# Staff Report for Administrative Subdivision Approval

**Application Request:** Consideration and action on an administrative approval of the Shannon Nielson Subdivision, a one lot subdivision

**File Number:** LVS 061716

SHANNON NELSON SUBDIVISION  
PART OF THE EAST HALF OF SECTION 17,  
TOWNSHIP 6 NORTH, RANGE 2 WEST,  
SALT LAKE BASIN AND MERIDIAN  
WEBER COUNTY, UTAH, JULY 2016

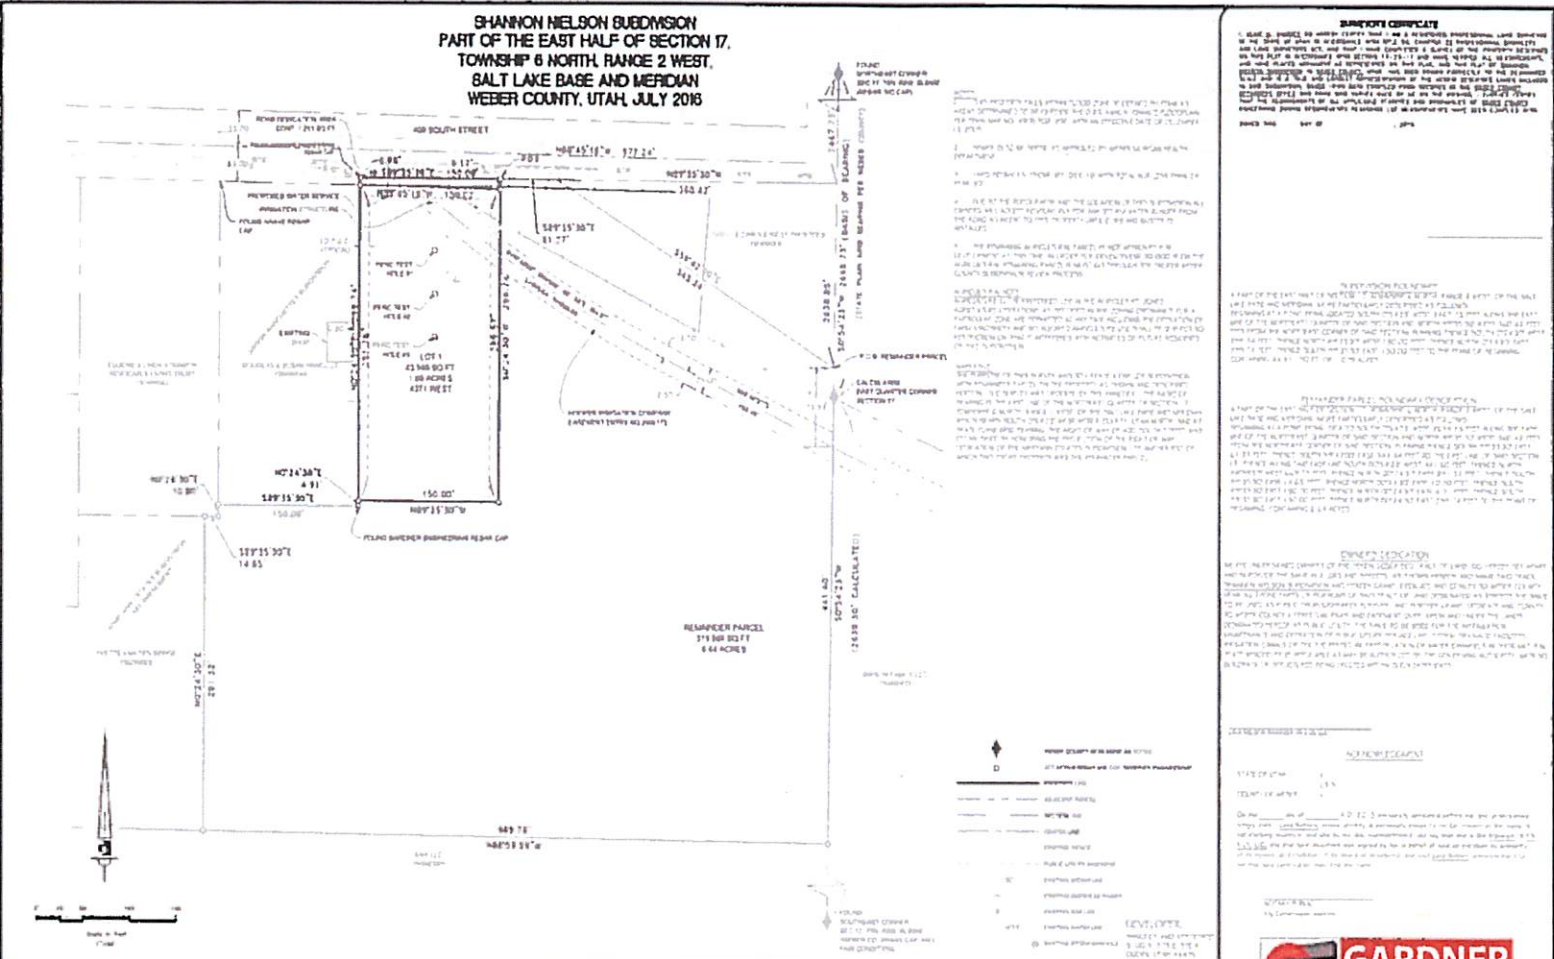
easement that runs from the northeast side yard line through the northwesterly area of the front lot line (see Exhibit A). All permanent structures will need to be built outside of the easement. A 10 foot public utility easement will be dedicated along the front and side yards and upon recording the property owner will dedicate a portion of the frontage to the County to ensure adequate right of way width along 400 south.

The remainder parcel will be 6.64 acres and the plat note #5 identifies the remaining agricultural parcel; however a condition of approval has been added to have the remainder parcel state "Remaining Agricultural Parcel, Not Approved for Development". A condition of approval has been added to ensure this modification has been made prior to recording the final plat.

1. The remainder parcel shall state "Remaining Agricultural Parcel, Not Approved for Development".
